424-430 WARREN AVENUE

BUILDING INSPECTION

CITY OF PORTLAND, MAINE
SITE PLAN REVIEW
 Processing Form

TO: Malcolm Ward, Building Inspection Department
FROM: Jeremiah O'Brien, Planning Department
SUBJECT: Site Plan Review - Global Energy Corporation

CUSTOMER REILLY TIRE CO. LOCATION 470 WARREN AVE CITY DATE J. 29. 80
 SCALE 1/4" = 1'-0"

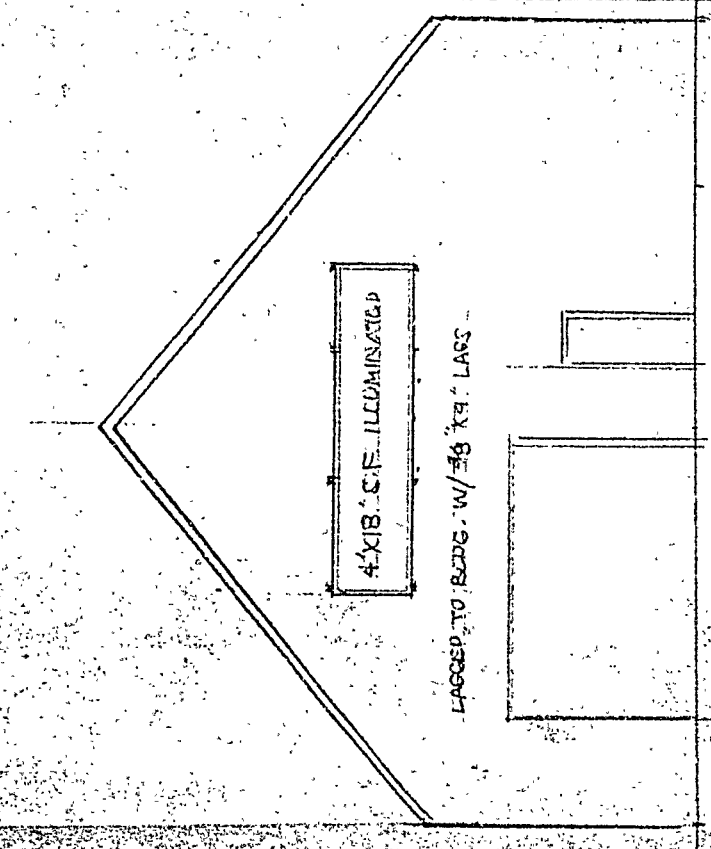
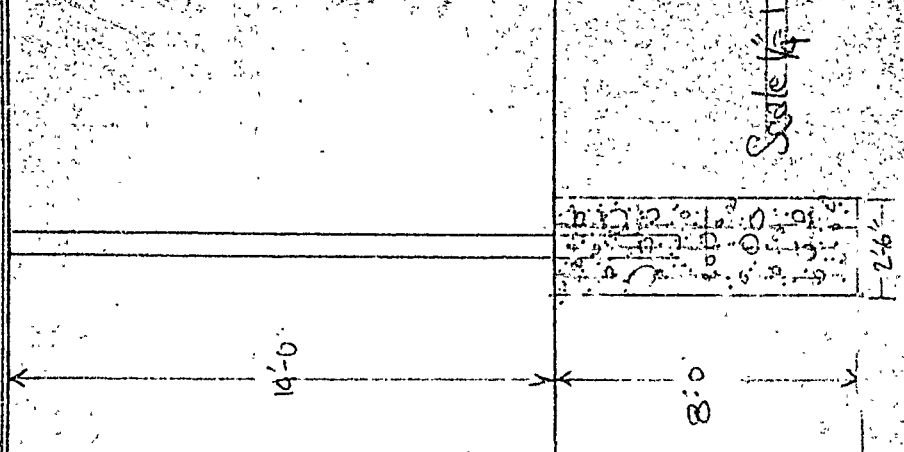
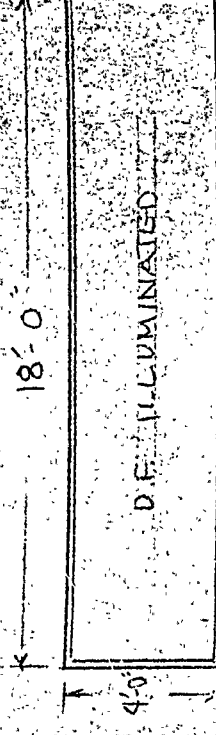
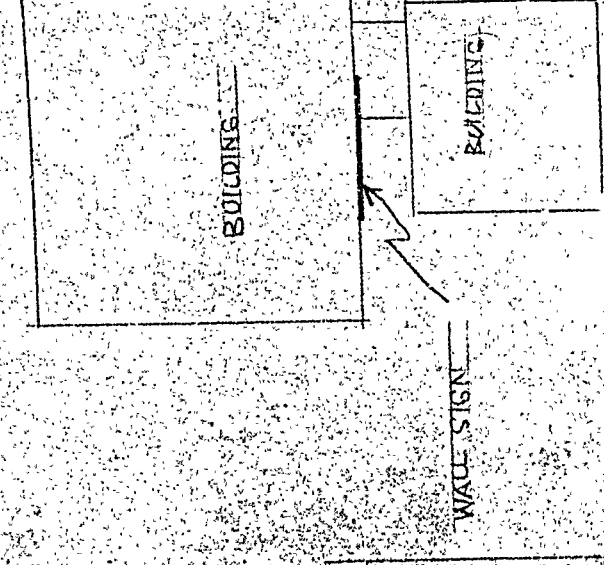
10-15-79 Not up yet
1-8-80 Sign bldg bldg is up, but
no pole sign yet
1-21-80 pole sign up but not as per
plans -> is double plate & 2 sign on's
will work better
2-6-80 See New Plans brought
in - if we didn't ask for
Amend -

It has been noted that the pole sign that has recently been erected, at the above location, is not as per approved plans. It will be necessary to come in and apply for an amendment showing the changes.

INSULATION PLANT
 SITE PLAN
 SHEET 1 OF 4
 2-21-78
 REUSED
 H.C. DINEEN

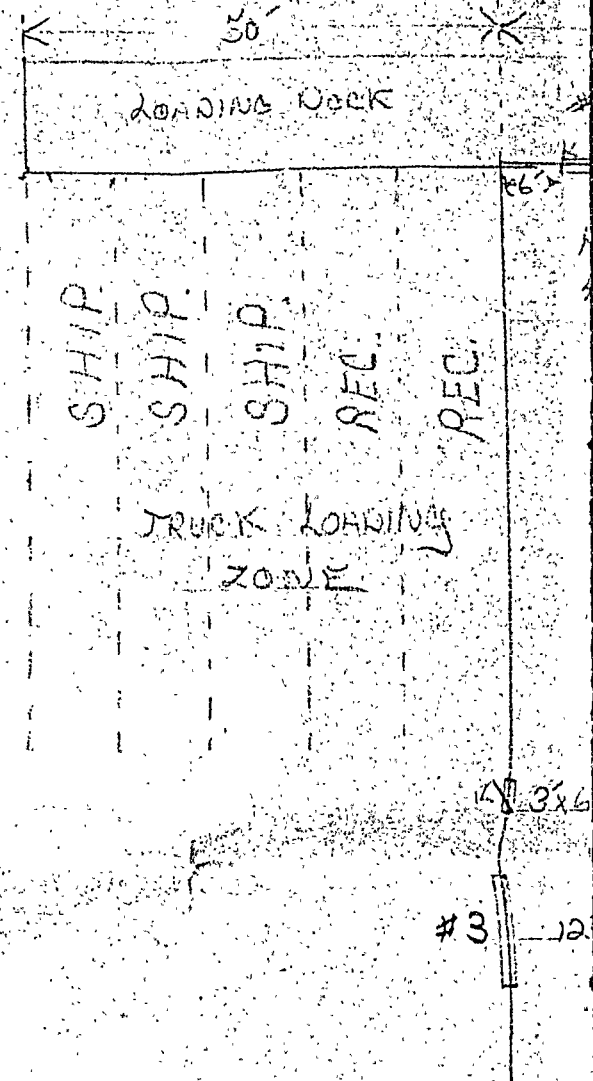
REASONS: More detail needed showing access to site & structure, turning room, safety hazards and water supply (hydrants).

Specifically, all existing and proposed areas which are to be paved should be delineated and labeled for their intended use, such as parking, driveways and truck storage/maneuvering areas. The existing curb cut should be shown as well as any proposed modifications. Sanitary sewer connections should also be shown.

ELEVATIONS
 MANUFACTURING
 PLANT SCALE 1/8" = 1'
 3 OF 4

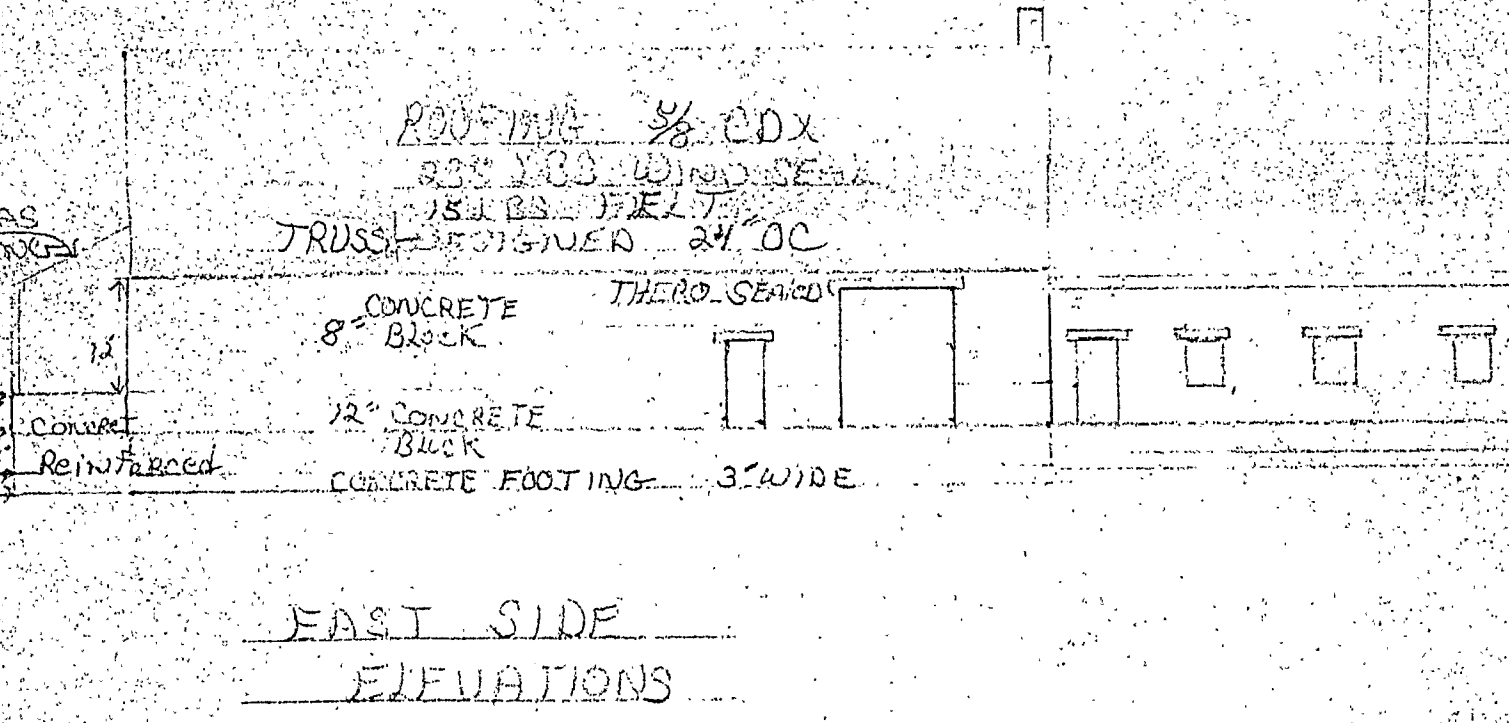
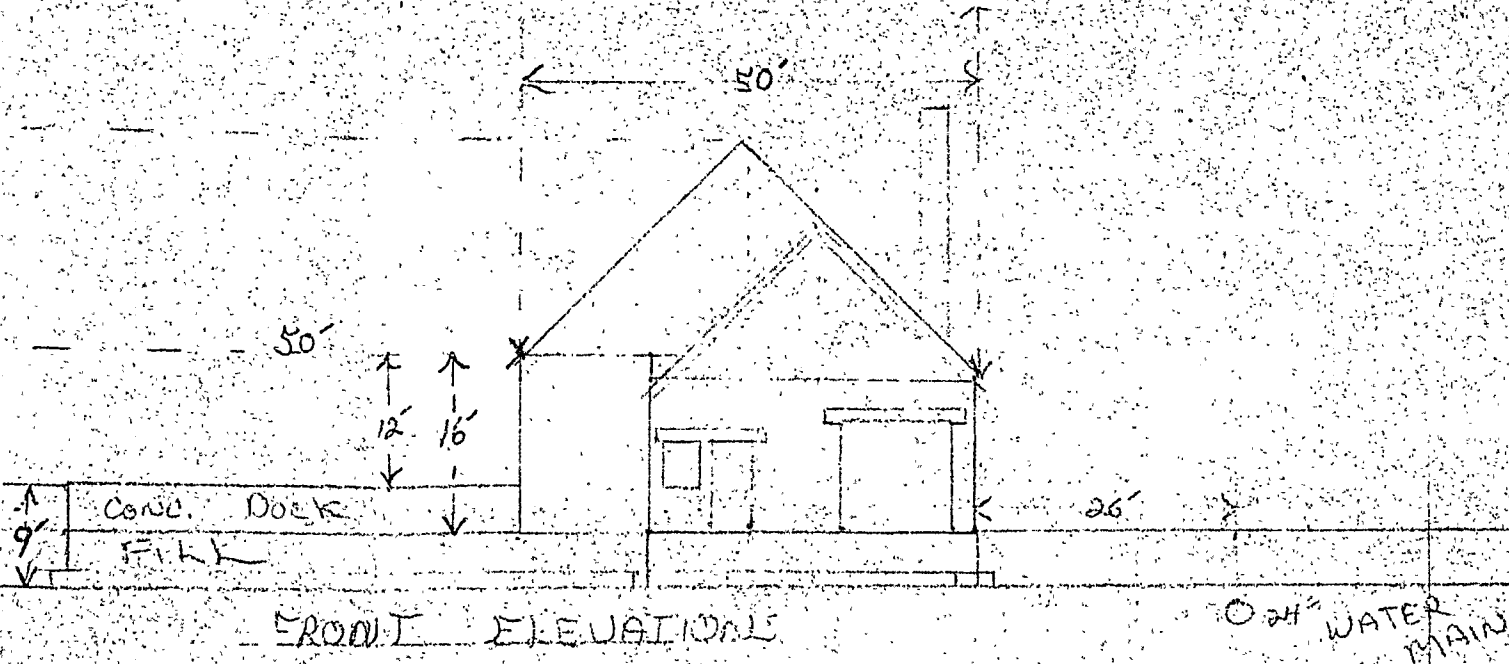
The 8" concrete blocks are to be no higher than 12 ft. of unsupported height, if higher than 12 ft., 12" concrete blocks must be used.
